## **NYISO Comments on Draft Proposed Reliability Rule 151 – Large Inverter Based Resources**

In consideration of the issues facing the industry in preserving the reliability of the electric grid, the NYISO appreciates the efforts put forward by the New York State Reliability Council (NYSRC) in the development of Proposed Reliability Rule (PRR) 151. As discussed by the NYISO at the February 8, 2023 TPAS/ESPGWG meeting<sup>1</sup> there are significant efforts underway at FERC, NERC, and the NYSRC to promote reliability with increased amounts of Inverter-Based Resources (IBRs). At the time of the February 8, 2023 TPAS/ESPGWG meeting the NYISO encouraged all IBR generator owners and developers to promote reliability by designing and operating their facilities in accordance with the requirements in the IEEE 2800 standard.

**Figure 2.2: Model Quality Verification Processes**

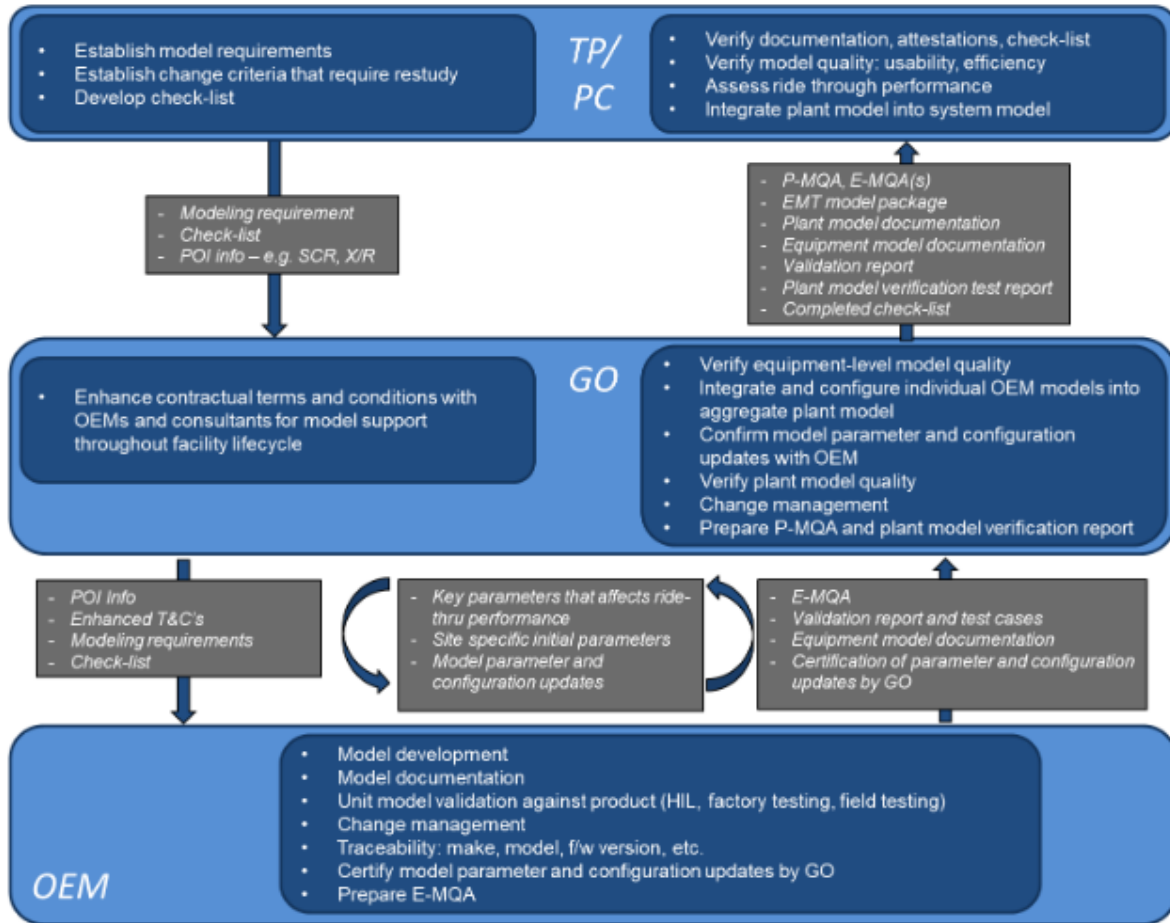
8. Within IEEE 2800, there are different layers or types of criteria. There are requirements that are mandatory (identified with a “shall”). Overall, there is a total of 67 mandatory requirements, of which 52 are required by the TS owner or TS operator. Of the recommended actions (identified with a “should”) there are a total of 49 requirements, of which 33 are to be determined by the TS owner or TS operator. Additionally, IEEE 2800 identifies possible 82 decisions (identified with a “may”) of which 76 are to be determined by the TS owner or TS operator. In consideration of the obligations placed on the AGIR, TS operator/TS owner, and IBR owner/IBR operator, there are 198 decisions the responsible entities can be involved with. Within Attachment A of PRR 151, the rule states that all requirements specified in IEEE 2800 shall be mandatory providing for no differentiation between the shall/should/may obligations within IEEE 2800. The NYISO recommends that the NYSRC provide clarification as to which of the decisions are requirements within the criteria (i.e., are all “should” and “may” statements also viewed as criteria). As stated above, and based on the volume of decisions that need to be made (again 198 shall/should/may) having this rule implemented within six months following EC approval of PRR 151 is infeasible. For example, in consideration of only the modeling criteria of IEEE 2800 (Section 10), there are a total of 6 “shall”, 2 “should,” and 1 “may” statements. While in number these are only a fraction of the items that need to be addressed in IEEE 2800, developing the process of a model quality verification process will require the development of several items to be considered such as those shown in the figure below (see NERC EMT modeling guideline published March 2023 [here](#)). The development of guidelines alone may

require assistance from industry experts on model verification, EMT, and other technical aspects.<sup>9</sup> As these Comments are available to the public, the NYISO cannot provide a detailed listed of 198 decisions IEEE 2800 requires as the restrictions provided in accessing IEEE 2800 prohibit making available any part of the standard to anyone other than Authorized Users.<sup>10</sup>
